Attachment 1

1. General topic: Consultation

TMR to address in 'Supplementary Information - Public Information Package report'

Figure 2-1 Conceptual model of sand movements at study area and surrounds

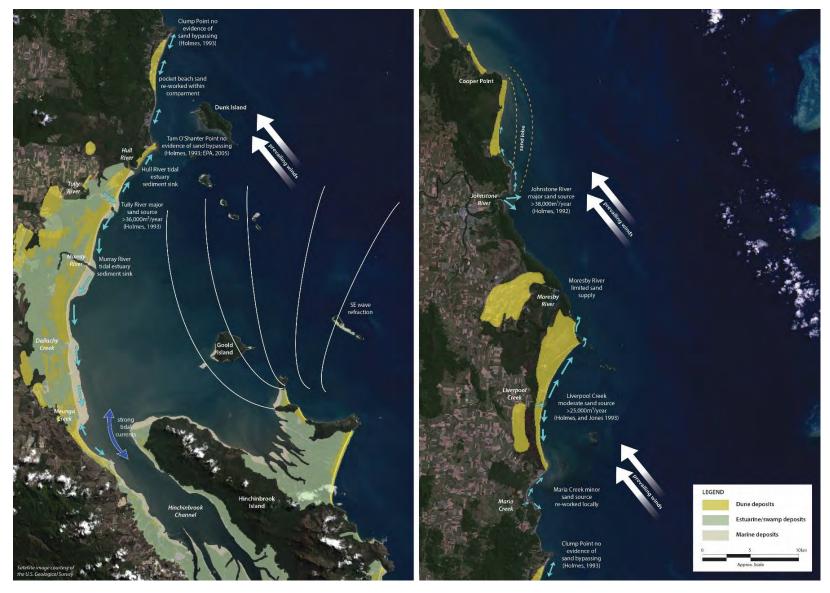
Impacts on beaches – concerns raised that the new breakwater would impact (erosion) on beaches to the north and south.

Appendix F provides description of coastal processes in the Clump Point area, and specifically provides figure 2.1 below:

Figure 4-5 Wave height impacts for 1-year ARI conditions. Left – North-Easterly direction; Right – South-Easterly direction.

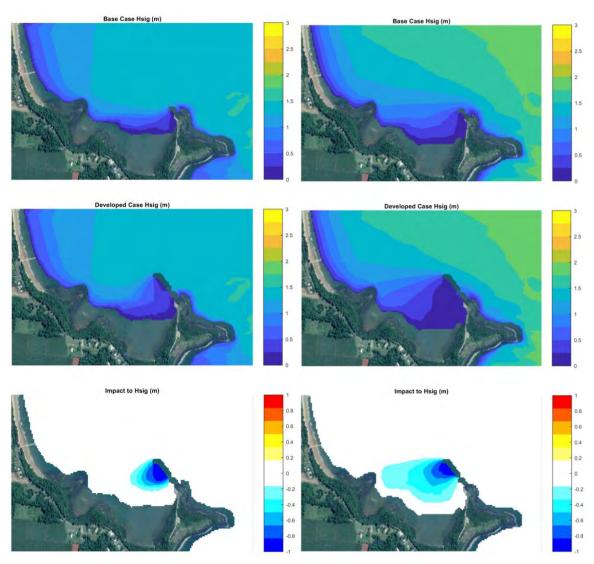
The GBRMPA query asks whether the potential impacts of northerly winds have been fully investigated. As shown in Figure 4-7 of the *Modelling Report*, only a very small percentage (~1.3%) of the long term wind record is from the N to ENE sectors and stronger than 6 m/s (required to generate appreciable wave action). That is, the GBRMPA query relates to a relatively unusual set of conditions.

Comparing the 1-year ARI NE wave condition (LHS of Figure 4-5 of the *Modelling Report*) with the SE wave condition (RHS of same figure), indicates that the wave sheltering impacts of the structure are in fact most pronounced for the SE case. On this basis it is considered likely that SE dominated conditions would yield higher siltation impacts for the Developed Case than NE conditions. Furthermore, given that NE conditions
